Access Compliance Report

(Curb Ramps)

Intersection ID: 2758	Main Street: BUCKSPRING_LN	Cross Street: SKYLINE_DR	Location: SW
ADA ID: 528968853901	Ramp Type: BlendTrans1	Initial Pass/Fail: Fail	Overall Compliance: No
Severity Score: 8.75			
Codes/Mitigation Info/Possible Solution		Field Measurements/Component Compliance

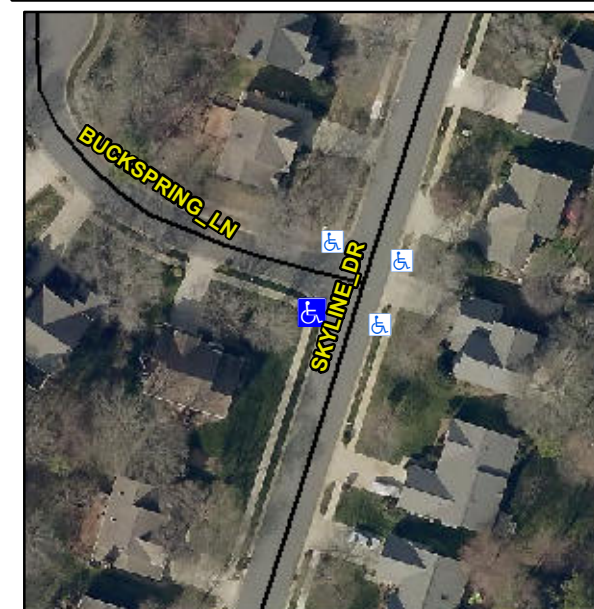
R304.5.1

Compliance	Description	Data	Compliance	Description	Data
N/A	Ramp Length (in)	50.0	Yes	BlendTrans Slope (%)	4.0
No	Ramp Width (in)	39.0	Yes	BlendTrans XSlope (%)	0.1
N/A	Flare Type LT	N/A	N/A	Flare Type RT	N/A
N/A	Flare Slope LT (%)	N/A	N/A	Flare Slope RT (%)	N/A
N/A	Flare Traversable LT?	N/A	N/A	Flare Traversable RT?	N/A
N/A	Landing Length (in)	N/A	N/A	DWS Provided?	N/A
N/A	Landing Width (in)	N/A	N/A	DWS Contrast?	N/A
N/A	Landing Slope (%)	N/A	N/A	DWS Length (in)	N/A
N/A	Landing X Slope (%)	N/A	N/A	DWS Full Width?	N/A
N/A	Landing Curb? (Y/N)	N/A	N/A	DWS Offset (in)	N/A
N/A	Shared Landing?	N/A			
N/A	Gutter Ponding?	N/A	N/A	Gutter Slope (%)	N/A
N/A	Gutter Lip Ht (in)	N/A	N/A	Gutter X Slope (%)	N/A
N/A	Painted X Walk1?	No	N/A	Painted X Walk2?	No
	X Walk 1 Direction	To N		X Walk 2 Direction	To E
	X Walk 1 Width (in)	N/A		X Walk 2 Width (in)	N/A
	X Walk 1 Slope (%)	1.8		X Walk 2 Slope (%)	2.3
	X Walk 1 X Slope (%)	2.2		X Walk 2 X Slope (%)	3.7

Remove & Replace Curb Ramp With Two New Directional Ramps or Equivalent.
